APPLICATION NO.	FILING DATE	FIRST NAMED INVENTOR	ATTORNEY DOCKET NO.	CONFIRMATION NO.
10/598,613	05/29/2007	Marc Peuker	59109US004	7832
32692	7590	05/28/2010		
3M INNOVATIVE PROPERTIES COMPANY				
PO BOX 33427				
ST. PAUL, MN 55133-3427				
EXAMINER				
PAGAN, JENINE MARIE				
ART UNIT		PAPER NUMBER		
3728				
NOTIFICATION DATE		DELIVERY MODE		
05/28/2010		ELECTRONIC

Office Action Summary

DETAILED ACTION

FIG. 8

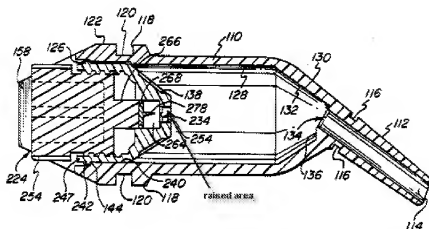
However Dragon discloses a separation wall 138 comprise a raised area (see figure above) extending towards said activator member 266.

It would have been obvious to one having ordinary skill in the art at the time the invention was made to have a raised area included in the separation wall as taught by Dragon, since Dragon shows in Fig 8 that such a modification would allow the two substances an area to begin to mix together.

However Dragan discloses (Fig 8) the raised area (see figure above) comprises an annular bulge.

It would have been obvious to one having ordinary skill in the art at the time the invention was made to have the raised area included in annular bulge as taught by Dragan, since *Dragan* shows in Fig 8 that such a modification would allow the two substances an area to begin to mix together in a curvature manner.

However Dragan discloses a separation wall 138 comprise a raised area (see figure above) extending towards said activator member 266.

It would have been obvious to one having ordinary skill in the art at the time the invention was made to have a raised area included in the separation wall as taught by Dragan, since Dragan shows in Fig 8 that such a modification would allow the two substances an area to begin to mix together.

However Dragan discloses (Fig 8) the raised area (see figure above) comprises an annular bulge.

It would have been obvious to one having ordinary skill in the art at the time the invention was made to have the raised area included in annular

bulge as taught by Dragan, since *Dragan* shows in Fig 8 that such a modification would allow the two substances an area to begin to mix together in a curvature manner.
